PROJECT NAME: COMMONWEALTH BUSINESS PARK

REVIEW COMMENTS

FILE #RP-96-171

TITLE HEADING: Commonwealth Subdivision

SITE PLAN/UTILITY COMPOSITE

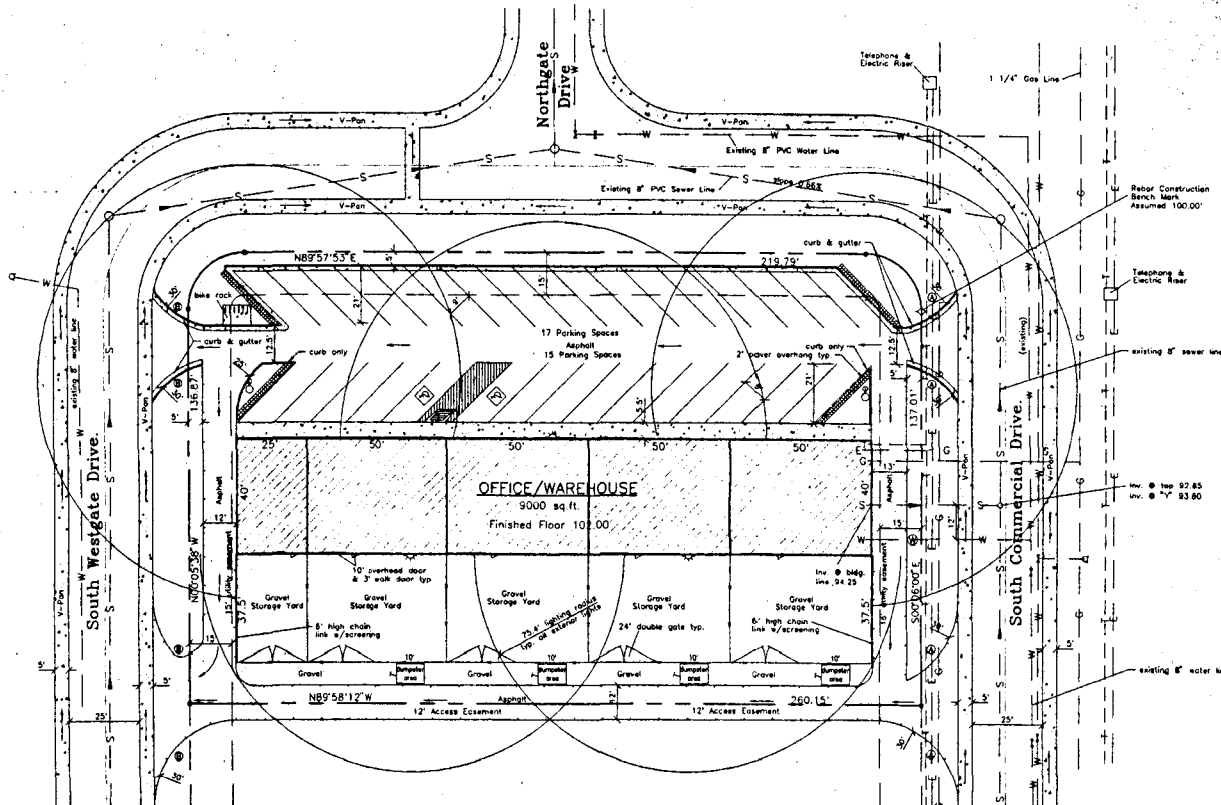
3. The parking lot dimensions do not appear to meet Code size requirements. The depth between the aisle way edge and the end of the parking stall needs to be 21 feet if the 45 degree parking is to be used. Currently, 17 feet is shown. *Verify w/ TEPs page 50*

5. Label on the site plan where the bicycle rack is being located.
6. The landscape plan looks very good as proposed. However, how will the landscape areas keep the bark and washed gravel from getting into the private and public roadways? What's going in the island on the southeast corner of the parking lot? Also, the landscape calculation box on the landscape plan is incorrect. The Development Code requires that the entire right-of-way area be landscaped. While the site plan does this, the landscape calculation box should reflect this requirement.

1. The proposed alley appears to partially on the adjoining parcel. Perhaps the plat should include the parcels to the south as well.
2. There is no easement provided on the plat for the alley. It appears an ingress/egress easement should be provided to allow adjoining properties to use it.
3. Please provide the calculations for the drainage fee based on the proposed plan. The calculation is detailed in the SWMM manual and the Zoning and Development Code.
4. The parking appears to be too narrow. Section 5-5-1 of the Zoning and Development Code provides a table of dimensions for parking at various angles. Please dimension the parking so there is no mistake on the dimensions.

It appears, by looking at the site plan, that there needs to be dedicated right-of-way along the south line of Lot 1.

In reference to Mike Pelletier's comments regarding the alley shared by proposed lot 1 and lots 7&8: this alley must be a minimum of 20' wide for emergency access to the south side of the proposed office/warehouse.

The lighting appears to be well planned. I would strongly suggest that the chain link storage areas be left transparent with no screening.

Response: The parking calculations on the parking and lighting plan have been amended to show the requested information. The office space will comprise about 17% of the building; however, as a worst case scenario, the parking was calculated based on 100% office space. This was done because until the building is actually leased, the number of employees in each warehouse unit will not be known.

Response: The City Transportation Manual (TEDS) was used for the parking dimensions based on instructions to use TEDS for transportation related planning received upon purchase of the manual. However, because the Code apparently supersedes the TEDS manual, the parking dimensions were changed to Code. May I suggest that the City either revise TEDS or send out clarification to all owners of TEDS manuals stating that the Code supersedes TEDS.

OK **Comment:** Label on the site plan where the bicycle rack is being located.
Response: The bicycle rack has been labeled as requested.

OK **Response:** A cross section has been added to the plan showing that the landscape bark and gravel will meet all edges of roadways on the level. This configuration will prevent landscape surface materials from washing into the roadways. The parking island was inadvertently left blank. It has now been filled in. The landscape calculation box has been changed to reflect the R.O.W. landscape requirement.

Response: The parking dimensions have been changed per Section 5-5-1. See response to Pelletier Comment 3 above.

Response: After conferring with Mr. Masterson, Mr. Pelletier has okayed the proposed 12' wide alley.

Response: The Code requires all storage areas greater than 150 sq.ft. to be screened; however, after conferring with other planners and Mr. Stassen, Mr. Pelletier has determined to screen only the ends of the storage, leaving the south side and the partitions transparent for security reasons. The plan has been changed accordingly.

GRADING & DRAINAGE PLAN

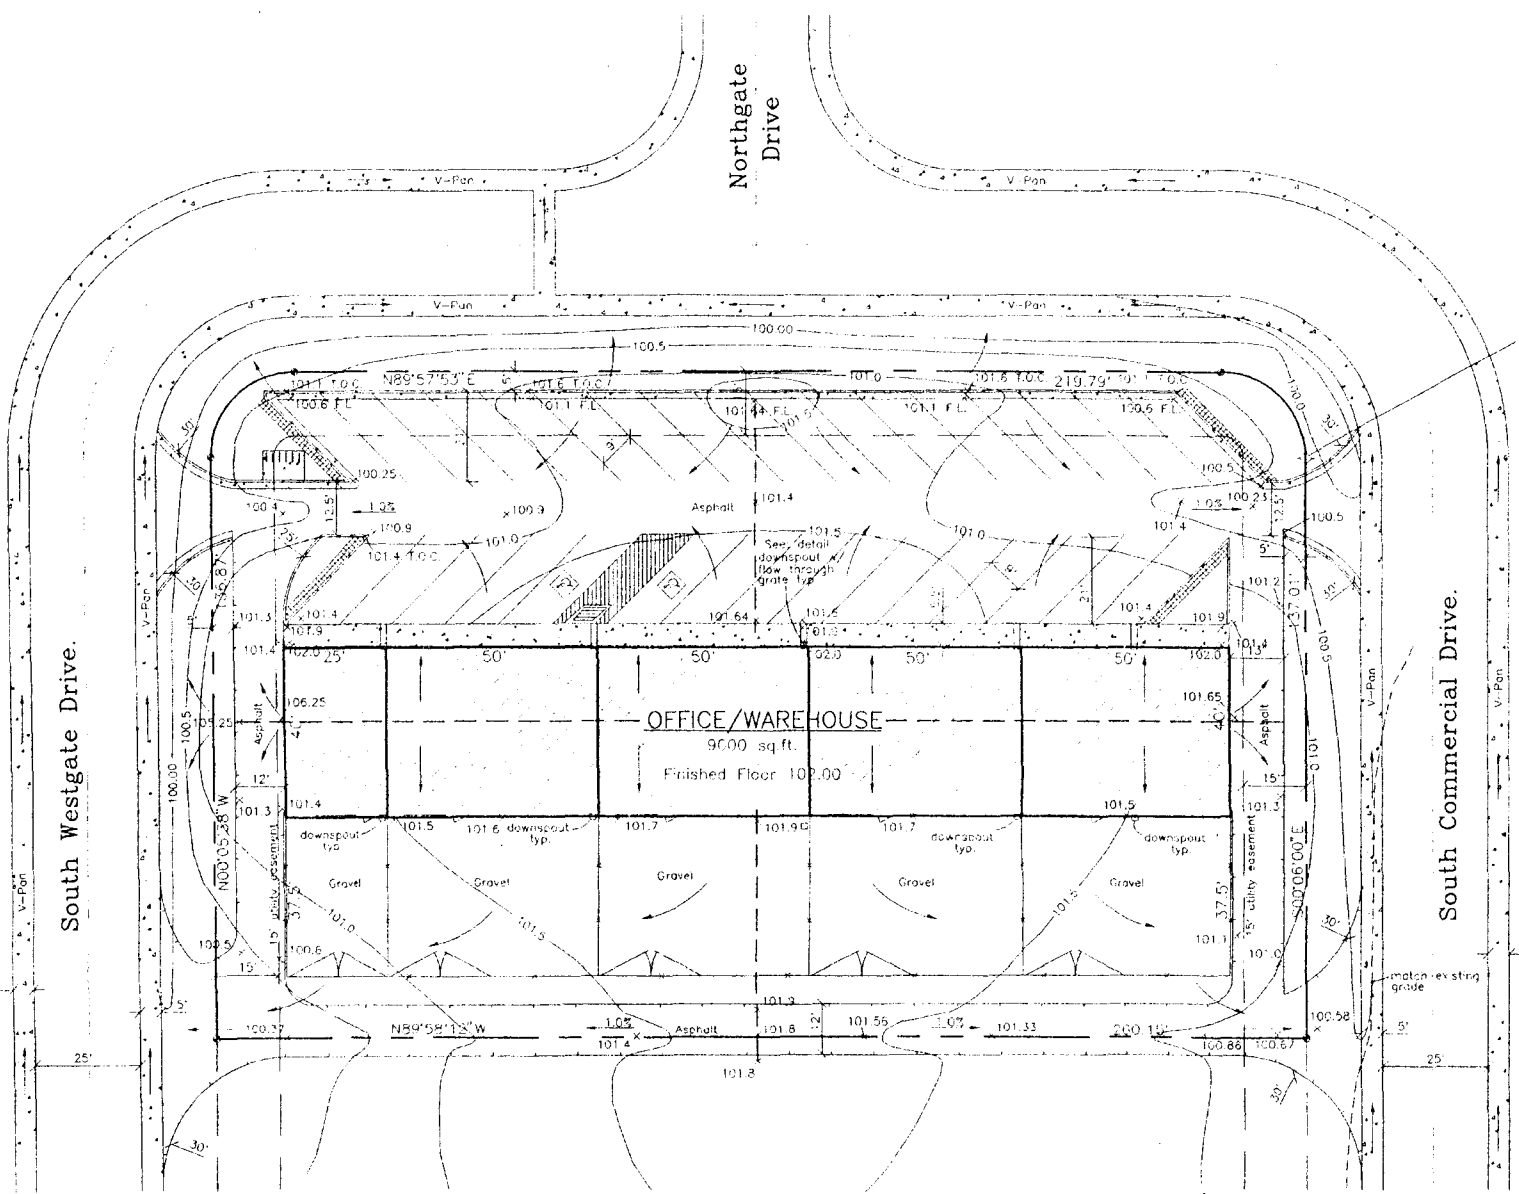
Comment: Please provide the calculations for the drainage fee based on the proposed plan. The calculation is detailed in the SWMM and the Zoning and Development Code.

Response: Drainage fee calculations have been added to the Drainage Plan.
